## ***Problem report document***

<b>Problem report oryginator</b>	<i>Michał Wołowik</i>	<b>Problem report date</b>	<i>16.XII.2010</i>
<b>PCB,Schematic revision</b>	<i>V3_0</i>	<b>Project name</b>	<i>Laboratory supply</i>
<b>Software revision</b>	<i>V1_0 testing</i>	<b>OS revision</b>	<i>FreeRTOS V6.0.5</i>

**1. Problem with voltage regulator.** Part of schematic figured below.

**Figure 4.** Relay gitter – low peek on output

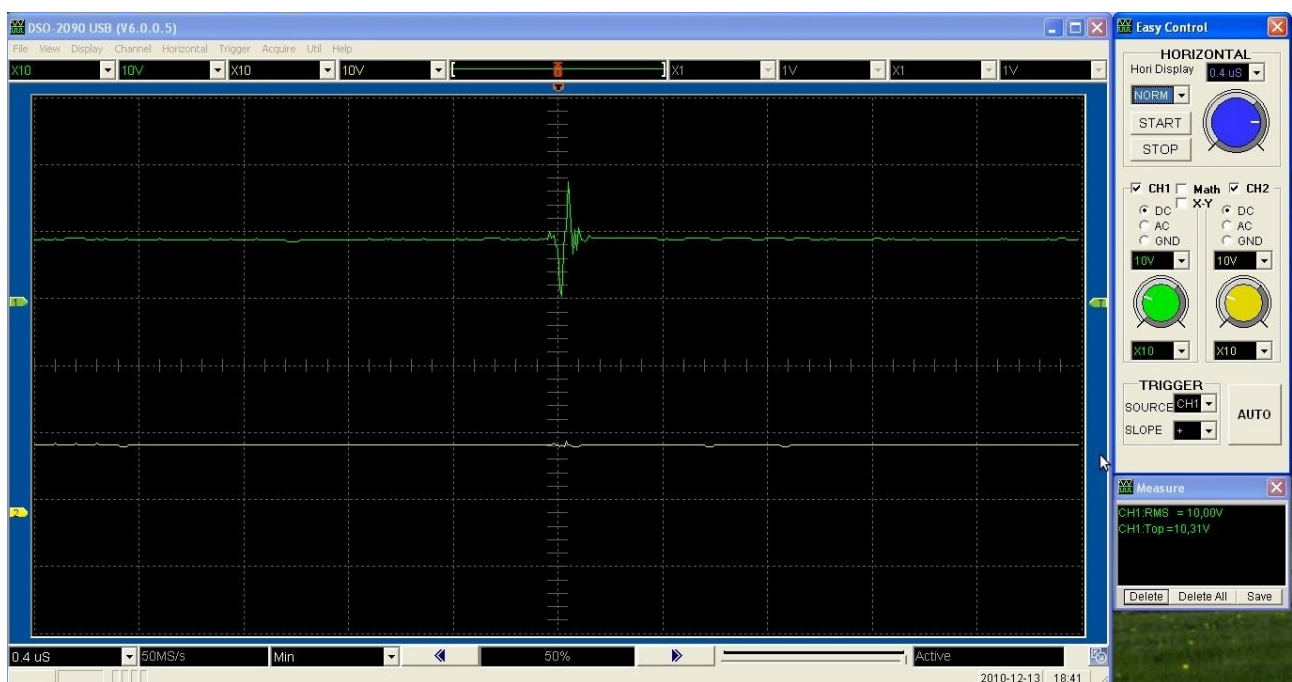
**Figure 3.** Relay gitter – very high peek on output
